# Access Compliance Report

## Public Rights-of-Way

Intersection ID: N/A	Main Street: S BREVARD ST	Cross Street: E 4TH ST	Location: S
ADA ID: 9FA6532308D9	Ramp Type: PerpDiag	Initial Pass/Fail: Fail	Overall Compliance: No
Severity Score: 46.25			
Codes/Mitigation Info/Possible Solution		Field Measurements/Component Compliance

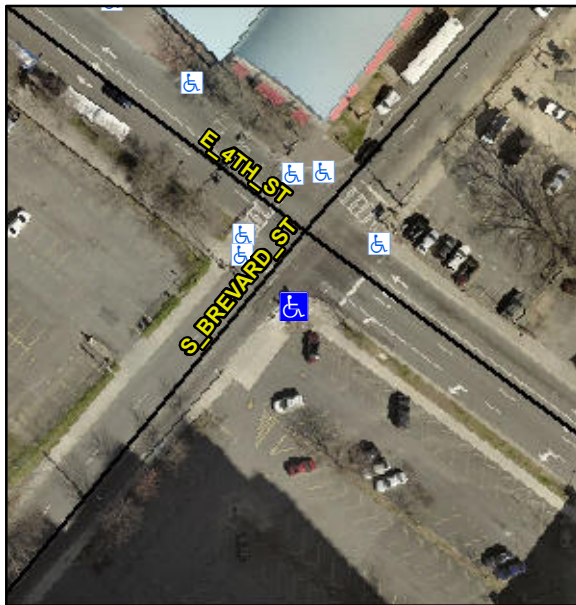
**R304.5.1, R304.2.2, R304.5.3**

Compliance	Description	Data	Compliance	Description	Data
N/A	Ramp Length (in)	73.0	No	Ramp Slope (%)	10.9
No	Ramp Width (in)	38.0	No	Ramp XSlope (%)	10.0
N/A	Flare Type LT	N/A	N/A	Flare Type RT	N/A
N/A	Flare Slope LT (%)	N/A	N/A	Flare Slope RT (%)	N/A
N/A	Flare Traversable LT?	No	N/A	Flare Traversable RT?	No
N/A	Landing Length (in)	N/A	N/A	DWS Provided?	N/A
N/A	Landing Width (in)	N/A	N/A	DWS Contrast?	N/A
N/A	Landing Slope (%)	N/A	N/A	DWS Length (in)	N/A
N/A	Landing X Slope (%)	N/A	N/A	DWS Full Width?	N/A
N/A	Landing Curb? (Y/N)	N/A	N/A	DWS Offset (in)	N/A
N/A	Shared Landing?	N/A			
N/A	Gutter Ponding?	N/A	N/A	Gutter Slope (%)	N/A
N/A	Gutter Lip Ht (in)	N/A	N/A	Gutter X Slope (%)	N/A
N/A	Painted X Walk1?	No	N/A	Painted X Walk2?	No
	X Walk 1 Direction	To NE		X Walk 2 Direction	To NW
N/A	X Walk 1 Width (in)	N/A	N/A	X Walk 2 Width (in)	N/A
	X Walk 1 Slope (%)	0.7		X Walk 2 Slope (%)	5.8
	X Walk 1 X Slope (%)	8.4		X Walk 2 X Slope (%)	3.0

**Remove & Replace Curb Ramp With Two New Directional Ramps or Equivalent.**
